# POST-REMEDIAL ACTION REPORT FOR THE MADISON FUSRAP SITE

MADISON, ILLINOIS

SEPTEMBER 2000

**Errata Sheet for the  
Post Remedial Action Report for the Madison FUSRAP Site  
Madison, Illinois  
September 2000**

Figure 3. Class 1 and Class 2 Survey Unit Measurements at the 25 Foot Level

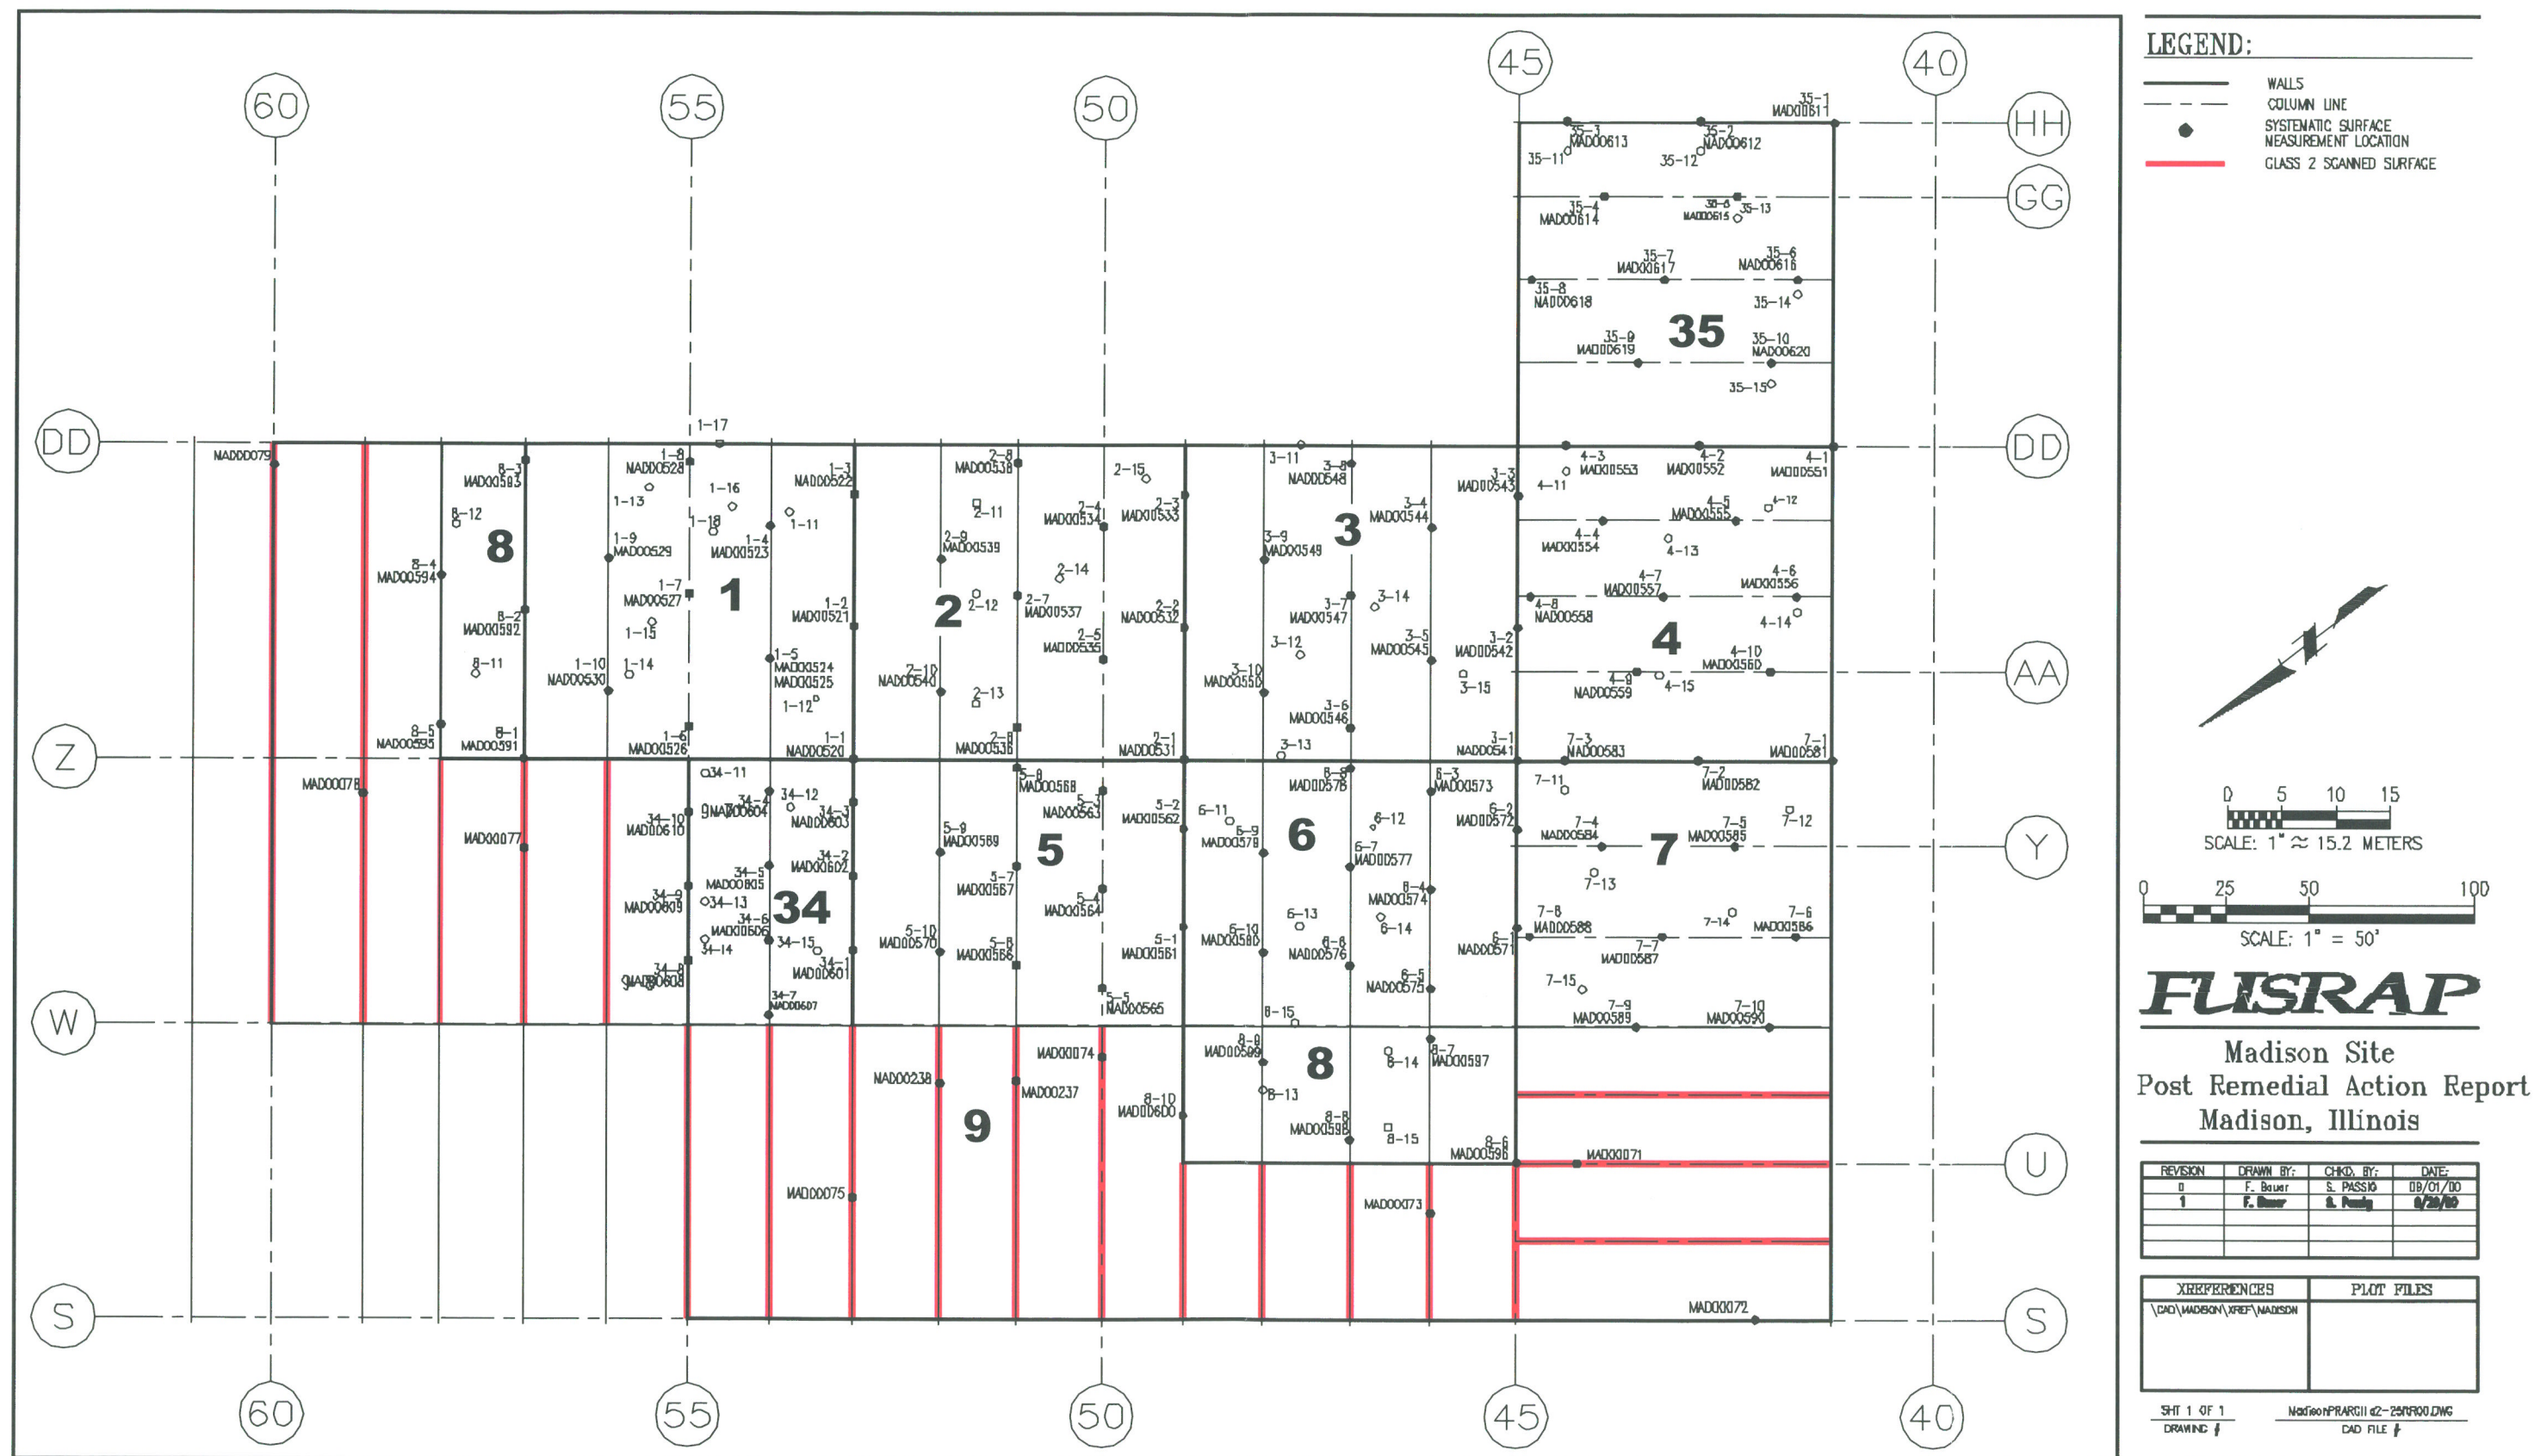
4. Figure 3, Legend. Add an unfilled circle to the legend with the text "The unfilled circles represent biased samples collected on cross member structure surfaces other than truss beam surfaces."

Figure 4. Class 1 and Class 2 Survey Unit Measurements at the 36 Foot Level

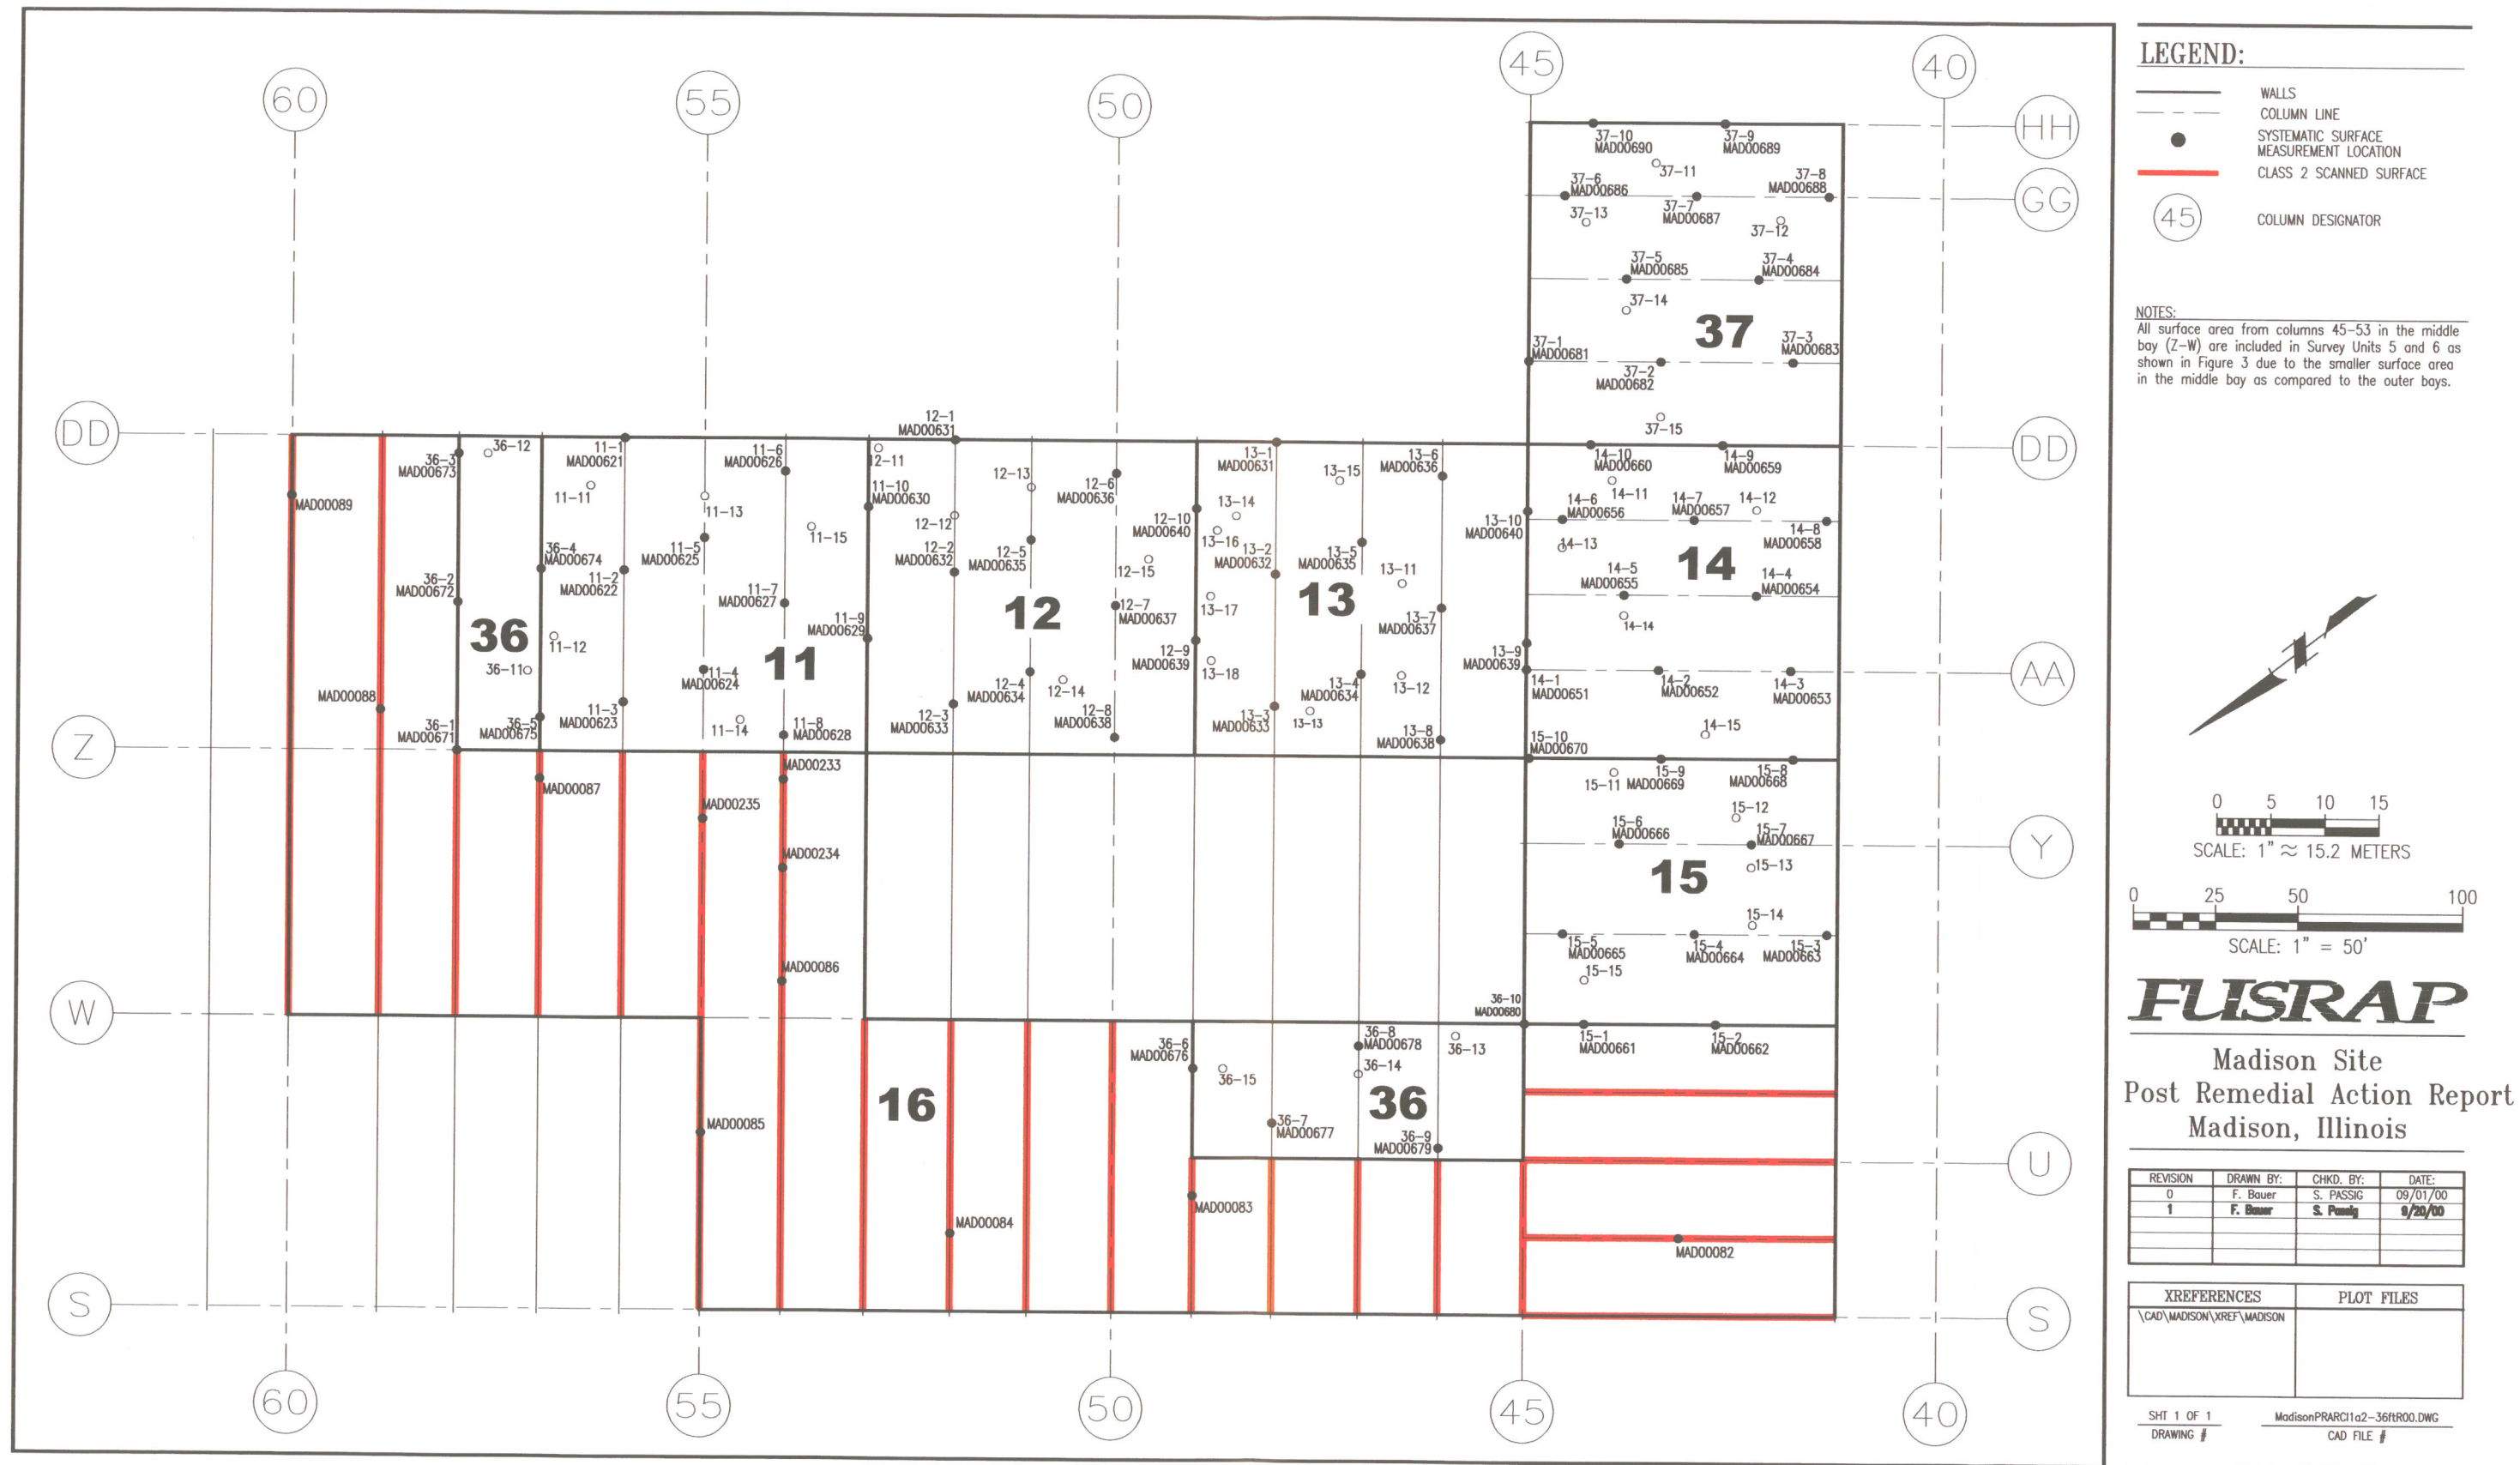
5. Figure 4, Legend. Add an unfilled circle to the legend with the text "The unfilled circles represent biased samples collected on cross member structure surfaces other than truss beam surfaces."

Figure 9. Class 3 Floor Survey Unit Measurements

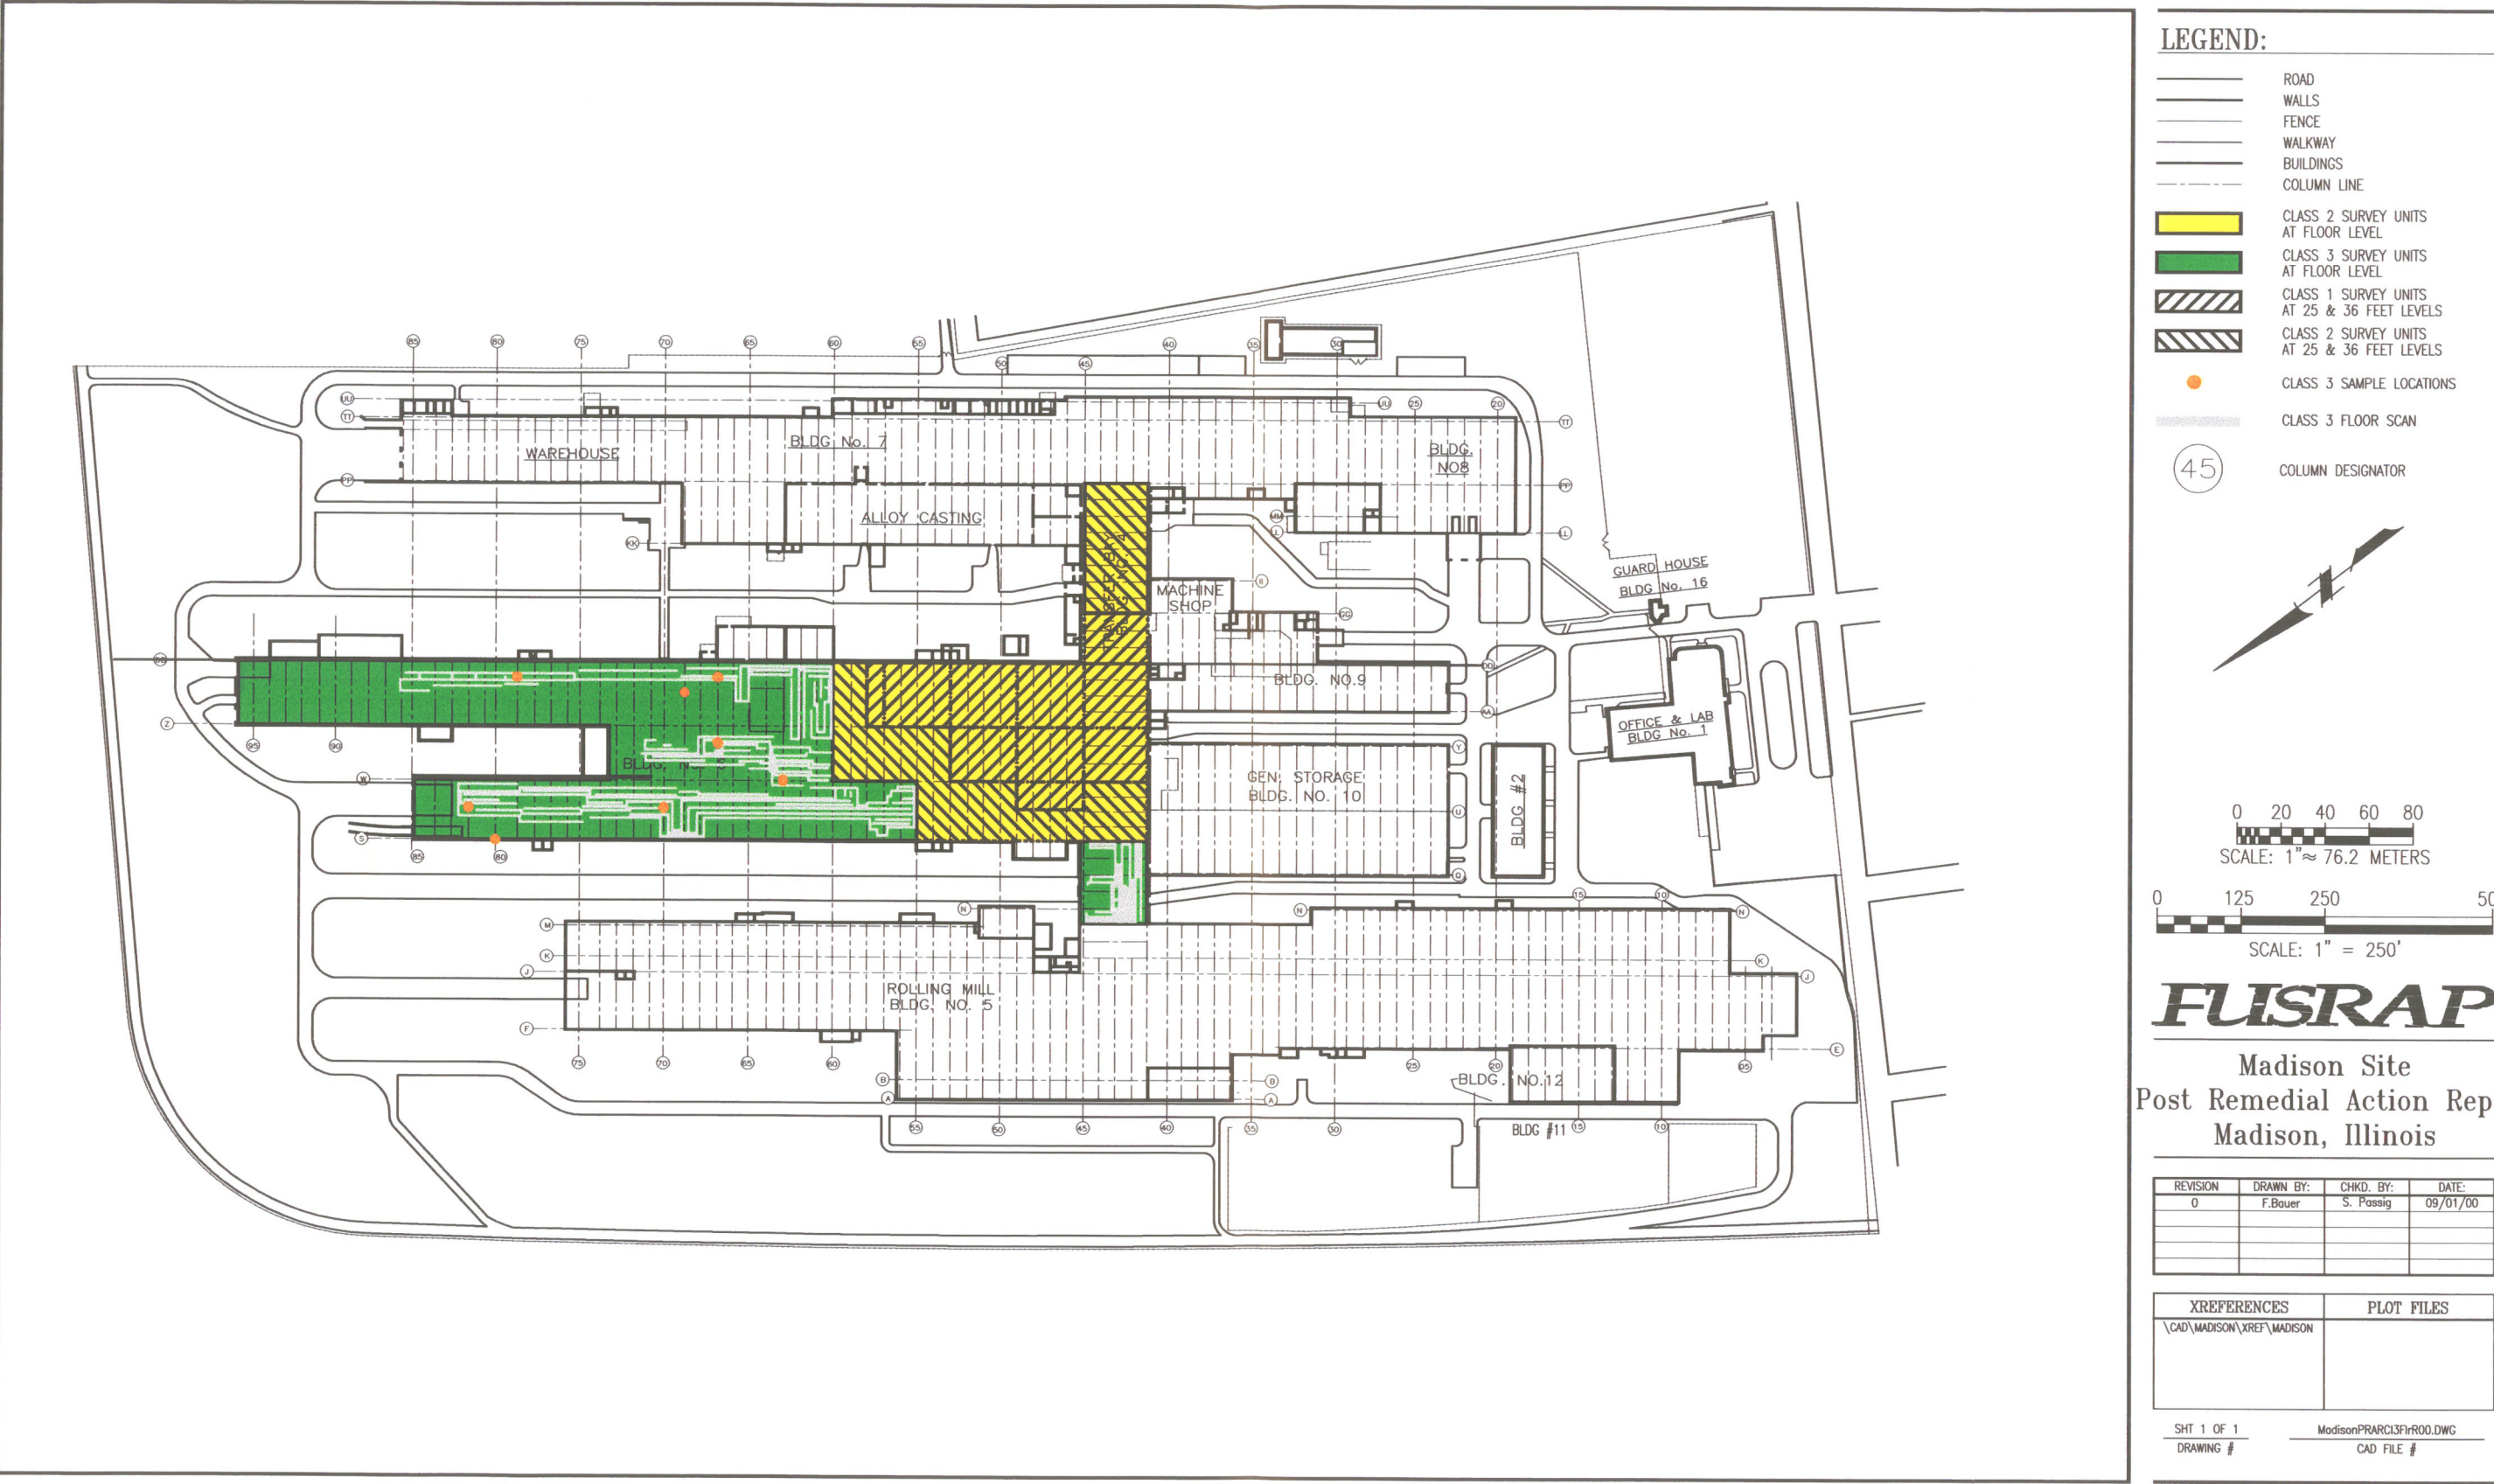
6. Figure 9, Legend. Add note to state: "The orange dots represent samples collected on cross members. Note that they do not have sample numbers because there were no measurements that exceeded even a small fraction of the DCGL in this survey unit."
